P 518558

A REPAIR

**ON-SITE SEWAGE DISPOSAL SYSTEM  
HOWARD COUNTY HEALTH DEPARTMENT  
BUREAU OF ENVIRONMENTAL HEALTH**

ADDRESS: 4445 Stonecrest Drive

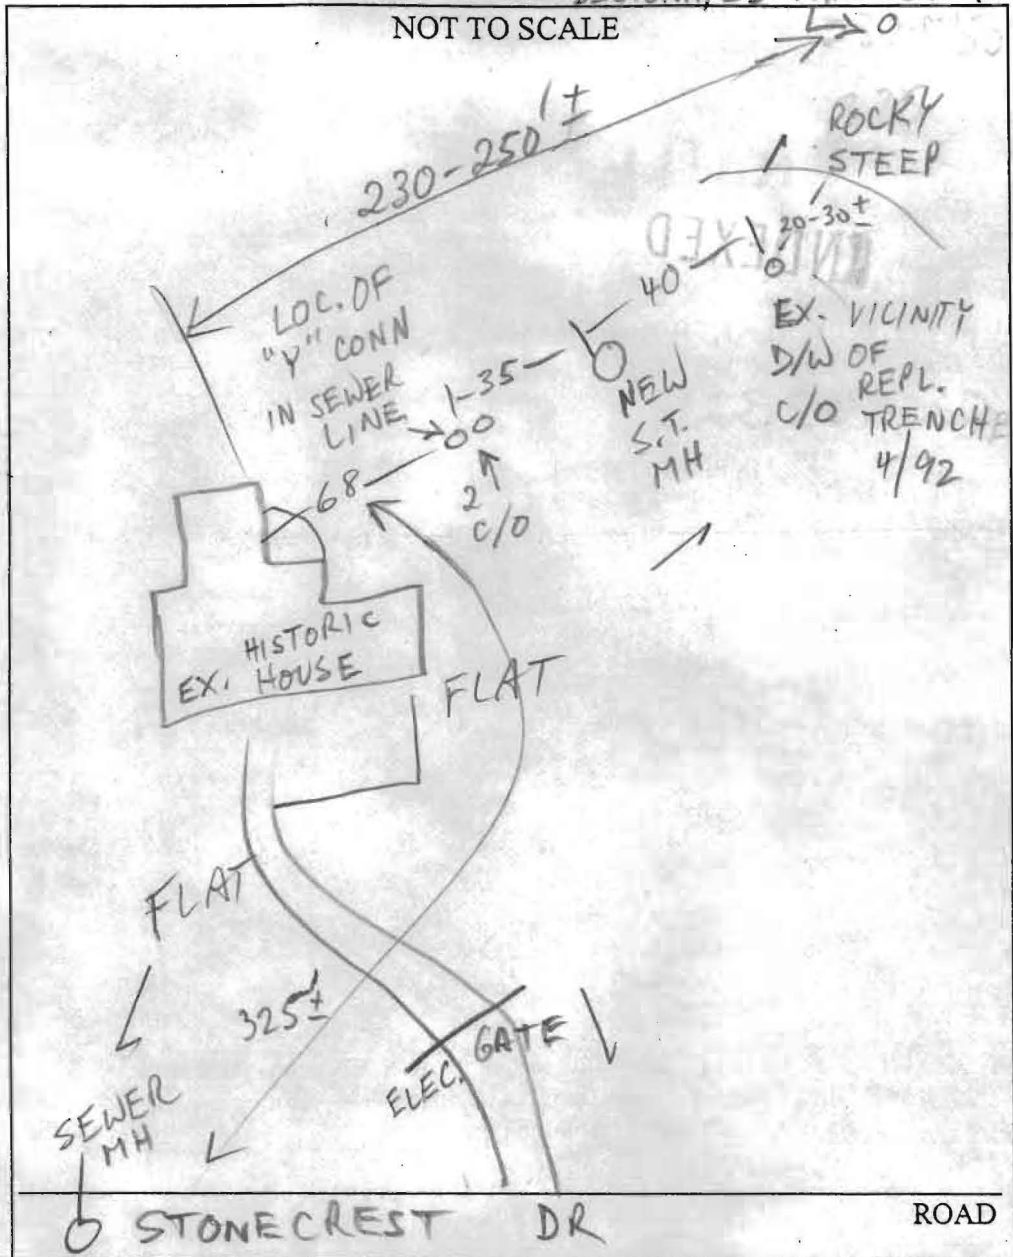
1/27/03 INSP REQUESTED  
FOR S.T. REPLACEMENT;  
CONTRACTOR ADVISED PUB.  
SEWER AVAILABLE, NO INSP WILL BE  
PROVIDED  
MR/GM

DESIGNATED MH FOR PUB. SEWER CONN PER ENG'G

PRE-CONSTRUCTION 1/29/03 MET INSTALLER TO COLLECT INFO TO DETERMINE PROPRIETY OF S.T. REPLACEMENT INSTEAD OF PUB. SEWER CONN. MR

INSTALLATION 1/29/03 AFTER REVIEW, CONN TO PUB. SEWER @ DESIGNATED MH NOT FEASIBLE DUE TO SLOPE, ROCK; S.T. REPLACEMENT ACCEPTED & APPROVED MR
